## Proposed Examination Foreclosure

## Appendix 1 - ERYC Solar Farm Comparisons

## Soay Solar Farm – a model for solar farm design

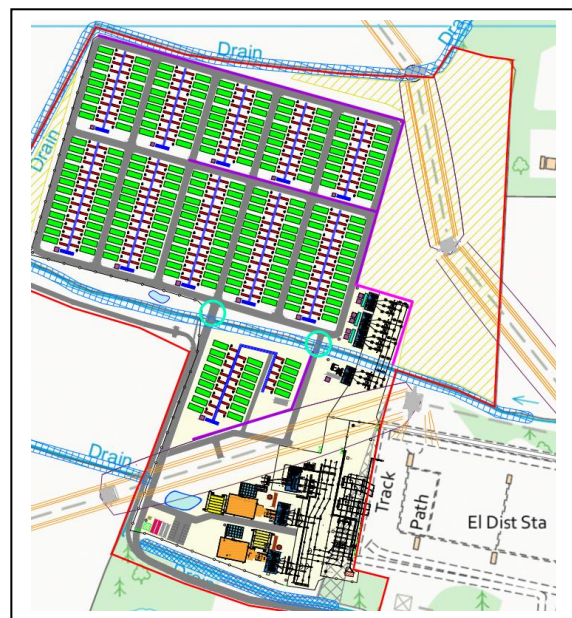
On the south-west perimeter there is a residence. Rather than plant PV panels up to the front door, the applicant has elected to set aside fields as a buffer zone around the house, along with hedging. (The blue triangles are sites planned as nesting boxes for sparrows.)

Soay includes a substantial battery (BESS) compound adjacent to the existing 400kV substation (bottom right). The energy capacity is not specified, but the housing within 200 shipping containers promises a significant facility. The Soay website explains that the batteries are also intended to provide grid balancing when not required for extending solar-derived electricity across the day. Thus, there is a two-way interface to the grid.

**Figure 6-6. GWh/Yr/MW decreases as overplanting increases, and losses are incrementally larger above a ratio of c.1.3.**

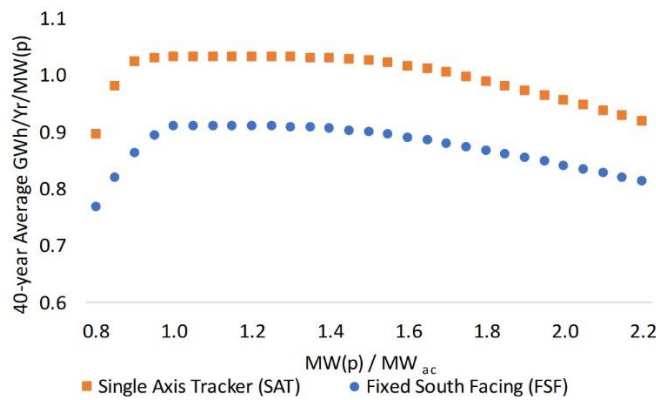
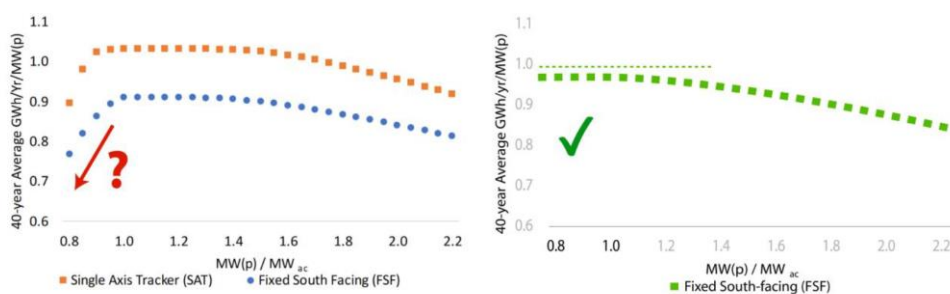
On page 23, there is a bizarre attempt to justify the "droop below 1" error in Fig 6-6 of the Statement of Need. This graph can be easily understood by any GCSE Science graduate (Appendix 2).

As the graph shows (and the legend states), overplanting reduces the yield of annual energy per  $MW(p)$  (because some of the available energy is curtailed). Looking at the graph, I would have said that losses are “incrementally larger” above 1.4 or 1.5 rather than 1.3 (as per the legend), but the determination is subjective. I also have no idea why these are dual-slope curves with a transition at around 1.4, but that too is another issue.

What does an overplanting ratio *below* 1.0 mean? It means that the inverter output rating *exceeds* installed capacity, and hence no curtailment will occur. Decreasing the overplanting ratio still further has no effect: the annual energy yield for each installed  $MW(p)$  will remain at its full value (green line below).

Energy-per-panels without droop below 1.0
